Affected Publication: API Standard 6A718, *Nickel Base Alloy 718 (UNS N07718) for Oil and Gas Drilling and Production Equipment*, 2nd Edition, December 2009

ERRATA 1

This errata corrects editorial errors in the 2nd Edition of API Std 6A718.

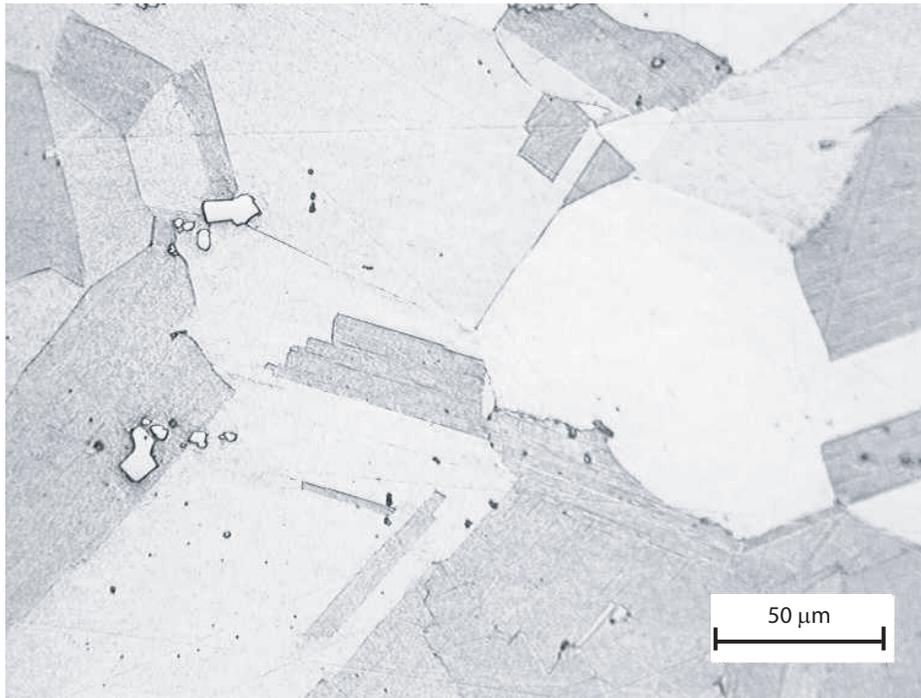
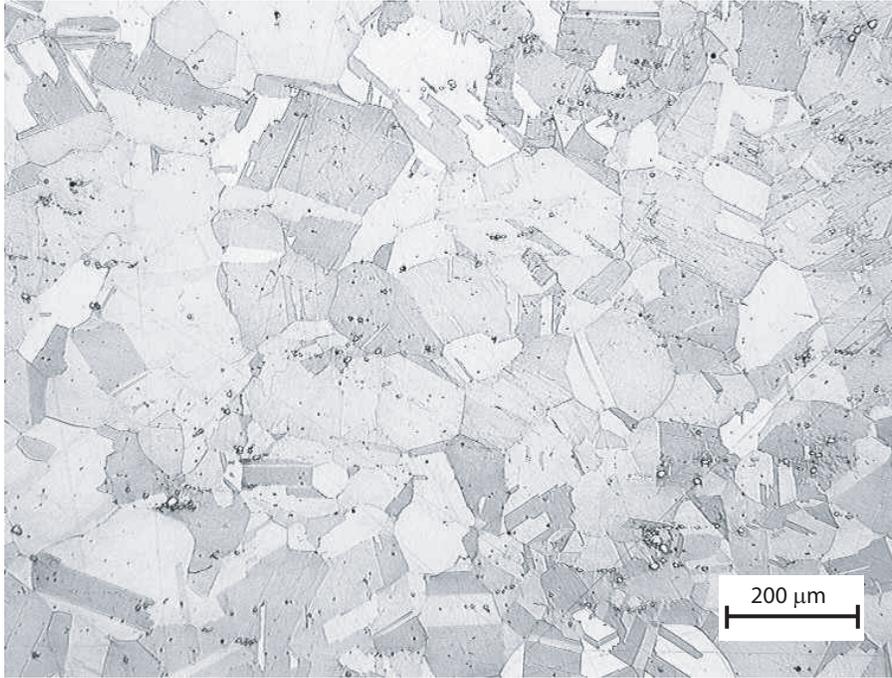
Pages 10 through 12, and pages 14 through 18. The measurement on Figures 1 through 6 and Figures 9 through 17 should read:

µm

not

mm
